CITY OF PROVIDENCE, RHODE ISLAND

RFP Title: Splashpad installation at Bucklin Park

Addendum #: 1

The purpose of this addendum is to respond to vendor questions.

2 PLUMBING & ELECTRICAL LAYOUT
PE-001 SCALE: 3/4"=1'-0"

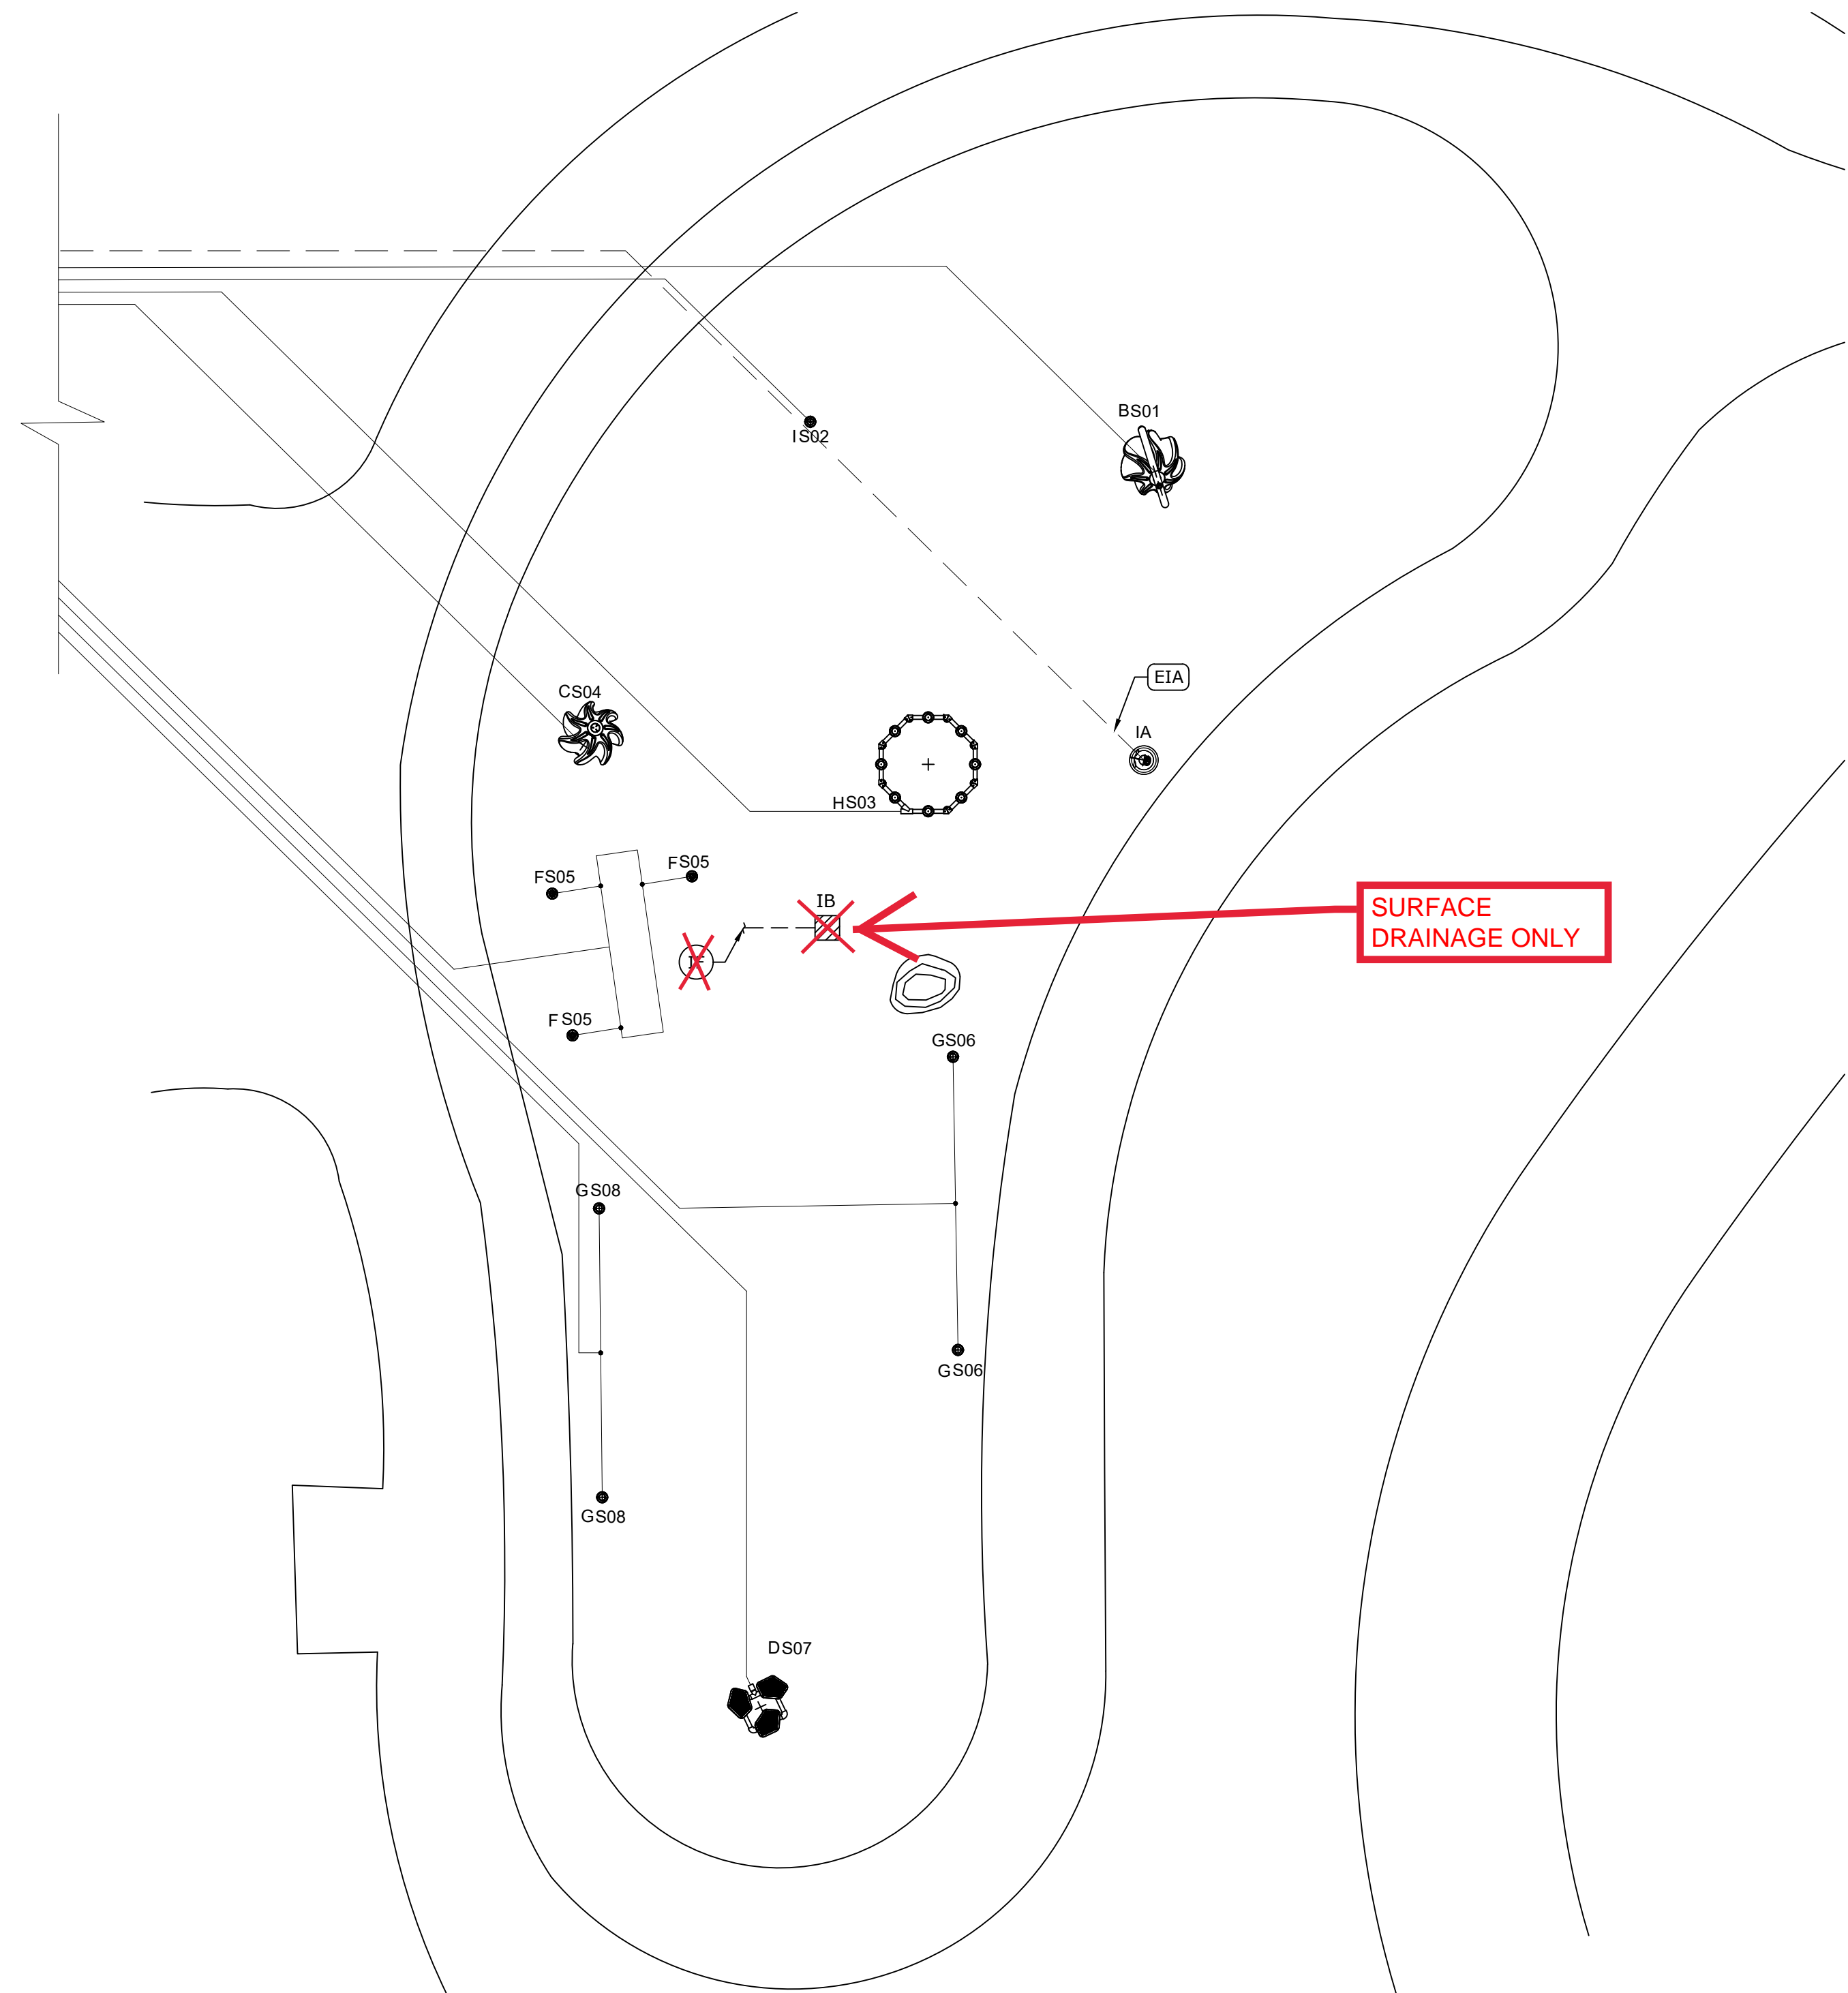
1. Q: How should the piping for the spray features exit the building?
A: The piping will go up into the ceiling and into the attic space and then come down the outside of the building (in conduit) and underground. The existing asphalt will have to be sawcut. See updates to plans L-2 & L-3
2. Q: What is the best way to access the site?
A: Currently the best access is either via the pool parking lot or from the Recreation center parking lot on Bucklin St. However, if the fence is temporarily removed, the site could be accessed from the side of the pool building.
3. Life Floor's preferred installer for their product is:
Inside Edge Safety Surfacing
Attn: Shawn Travis
612-220-1717
shawn@safetysurfaces.com
